UNITED STATES PATENT AND TRADEMARK OFFICE

APPLICATION NO.	FILING DATE	FIRST NAMED INVENTOR	ATTORNEY DOCKET NO.	CONFIRMATION NO.
10/729,582	12/06/2003	Benjamin Jian	AFC-002/RE	2222
27652 7590 03/28/2007 JOSHUA D. ISENBERG JDI PATENT 809 CORPORATE WAY FREMONT, CA 94539			EXAMINER PAK, SUNG H	
			ART UNIT 2874	PAPER NUMBER
SHORTENED STATUTORY PERIOD OF RESPONSE		MAIL DATE	DELIVERY MODE	
3 MONTHS		03/28/2007	PAPER

Office Action Summary

DETAILED ACTION

FIG. 20

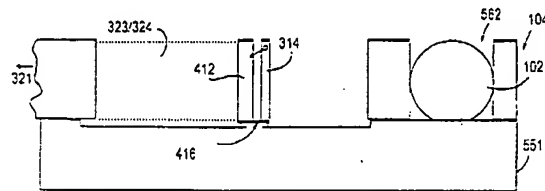
The earliest prior art that discusses the use of deep reactive ion etching for forming optical fiber alignment structure is Hurst, Jr. et al. (US Pat. 6,360,035 B1). Figure 20 of Hurst reference is reproduced below.

In column 20 lines 9-20, Hurst explicitly teaches the use of a deep reactive ion etching for forming an alignment groove (562) precisely formed to accept an optical fiber (102) therein. However, Hurst fails to teach or suggest forming a cylindrical alignment fiber socket extending through the substrate as claimed in the instant application.
